Subject: River Bend Station - Unit 1
Docket No. 50-458
License No. NPF-47
License Amendment Request (LAR 94-10) - Change to Technical
Specification 3/4.2.2, APRM Setpoints

ATTACHMENT 1
PROPOSED
ENTERGY OPERATIONS, INC.
DOCKET 50-458/LICENSE NO. NPF-47

APRM SETPOINTS
(94-10)

ITEM: **3/4.2.2, Pages B 2-1, 3/4 2-7, and 3/4 2-7a**

Figure 2: APRM Flow-Biased Setdown Trip Setting

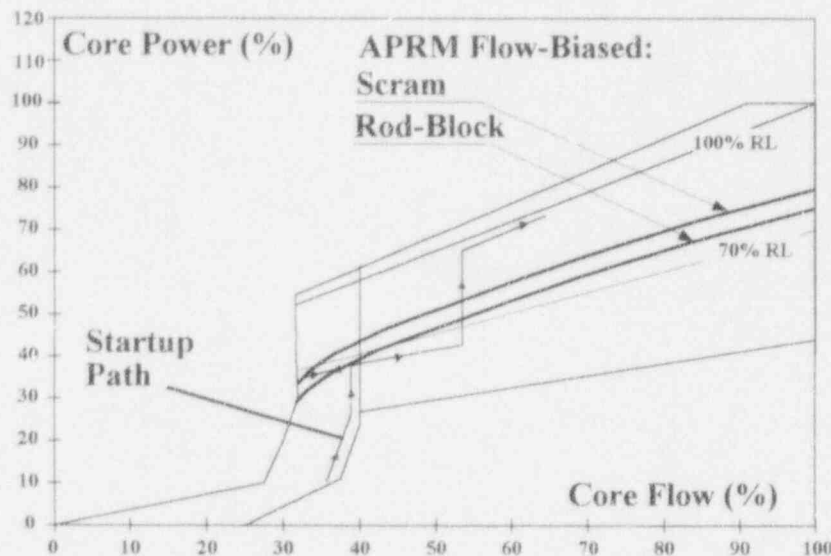
Figure 2 illustrates the APRM flow-biased scram and rod-block trip setpoint setdown as an example with a T of approximately 0.7, along with the example startup path. The resulting domain available for operations, in this example, can be seen to be considerably reduced and the normal startup path will not be viable. During startup, reactor power is increased to clear the feedwater flow interlocks for recirculation pump upshift. Once the interlocks are cleared the recirculation loop flow control valves are closed, one at a time, to the minimum position and flow approaches minimum forced circulation conditions. Once the flow control valve (FCV) is closed for minimum flow the recirculation pump is shifted to high speed. Power ascension continues subsequent to upshift of both pumps.

For the example startup, with T of approximately 0.7, the APRM trip setpoints are setdown such that a control block trip signal is received at the power level necessary for recirculation pump upshift. Additionally, closure of the FCVs to the minimum position approaches the APRM scram trip setpoint. Under these conditions, recirculation pump upshift and continued power ascension is not possible.

Figure 3: Confirmation of Modified T-Factor LHGR Protection

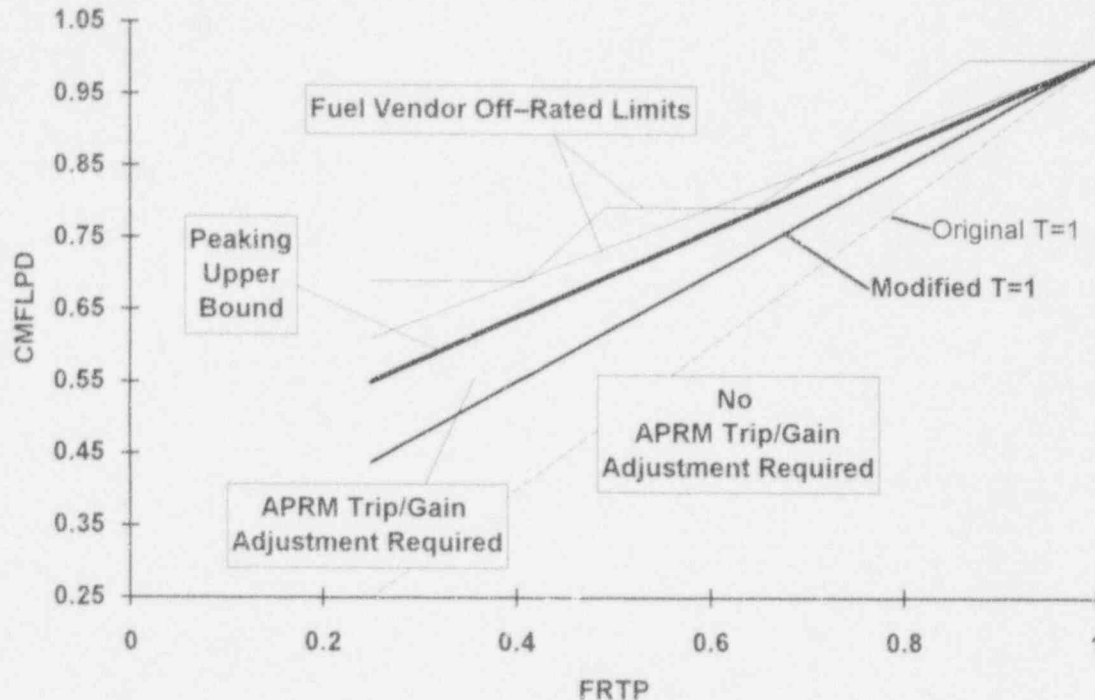
The original and modified APRM setpoints T-factors are shown in Figure 3. The original APRM setpoints T-factor requires APRM gains or trip setpoints adjustment for CMFLPD values exceeding the line defined by the original APRM setpoints T-factor equal to one. The modified APRM setpoints T-factor imposes the same requirement if the modified APRM setpoints T-factor is equal to one. The definition of the modified APRM setpoints T-factor, which provides for greater operational margin to comply with the required stability controls, can potentially result in higher peaking and, therefore, higher off-rated LHGR values.

The LHGR protection provided by the modified APRM setpoints T-factor definition is confirmed by comparing the modified APRM setpoints T-factor definition to power- and flow-dependent limits for LHGR protection established by the fuel vendor based on a database of analyses of limiting transients (AECM-86/0129), as illustrated in Figure 3. The off-rated LHGR limits address all limiting anticipated operational occurrences at off-rated conditions. These limits are applicable to RBS since the basis of the limits is an analytical data base of analyses of the limiting transients for determination of LHGR margin and are confirmed conservative for application to a BWR/6 of similar plant and fuel design as RBS.

A significant margin to the LHGR limit exists without APRM gains or trip setpoints adjustment. LHGR protection for reactor operation with APRM gains or trip setpoints adjustment, up to and including the peaking upper bound, is confirmed by the fuel vendor off-rated LHGR limits. The additional constraint on the modified APRM setpoints T-factor definition, that for high peaking the definition of T revert to the current Technical Specifications definition, ensures that the peaking upper bound is not exceeded. Operation in this region is not possible given the low value of T calculated with the current Technical Specifications definition and the requirements enforced by the APRM gains or trip setpoints adjustment. Because the peaking upper bound enforces a

$$T = \frac{3 \times \text{F RTP} + 1}{4 \times \text{CMFLPD}} \quad \text{provided } \text{CMFLPD} \leq 0.6 \times \text{F RTP} + 0.4, \text{ otherwise}$$

$$T = \frac{\text{F RTP}}{\text{CMFLPD}}$$

T is applicable only if it is less than or equal to 1.0
